From: Laura Gibbons
Sent: 23 June 2020 13:56
To: Planning.Responses [REDACTED]
Cc: Simon Davis [REDACTED]
Subject: N of Summer Lane P/35/20/DOC & P/37/20/DOC

We have the following comments regarding the revised surface water drainage details submitted for P/35/20/DOC and P/37/DOC.

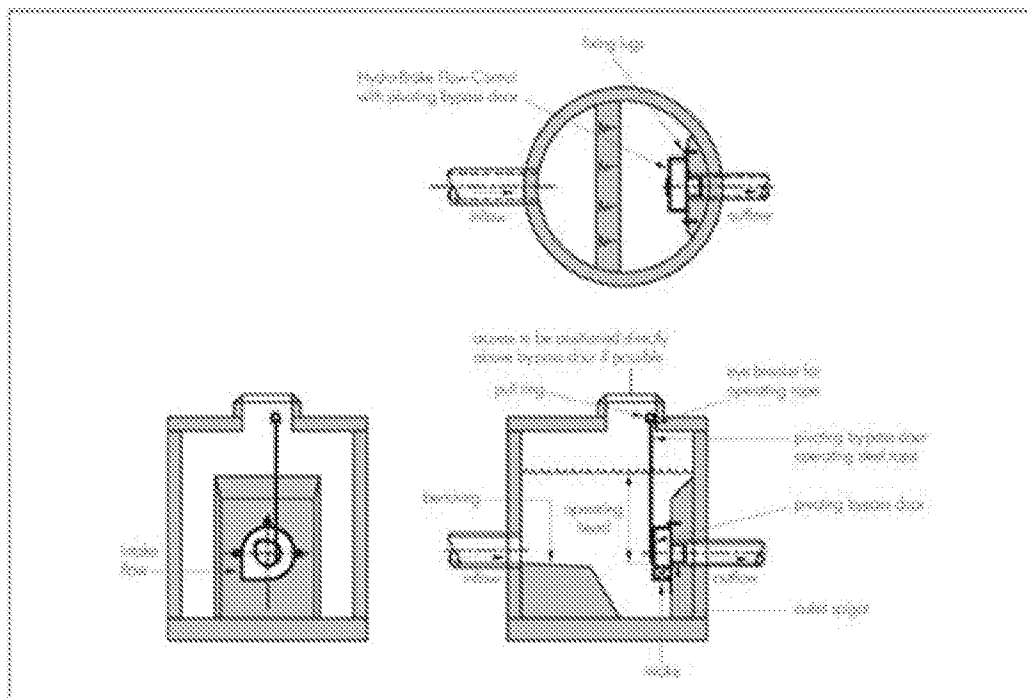
14. All hydrobrake chambers – pull handle to be attached to a point vertically above the hydrobrake. It's not clear how this is possible when the opening is offset from the hydrobrake and the pull handle attaches to a bracket at the manhole opening. *Access should be positioned directly above bypass door, as per hydro international standard details.* The rope runs through an eye bracket to allow operation. The alignment of the rope allows is aided by the eye bracket which is common practice. A 675x675 clear opening is required for stepped access to the base of the manhole hence the manhole opening cannot be directly over the hydro brake but the pull rope and eye bracket have now been positioned as close as possible directly above the hydrobrake in both cases.
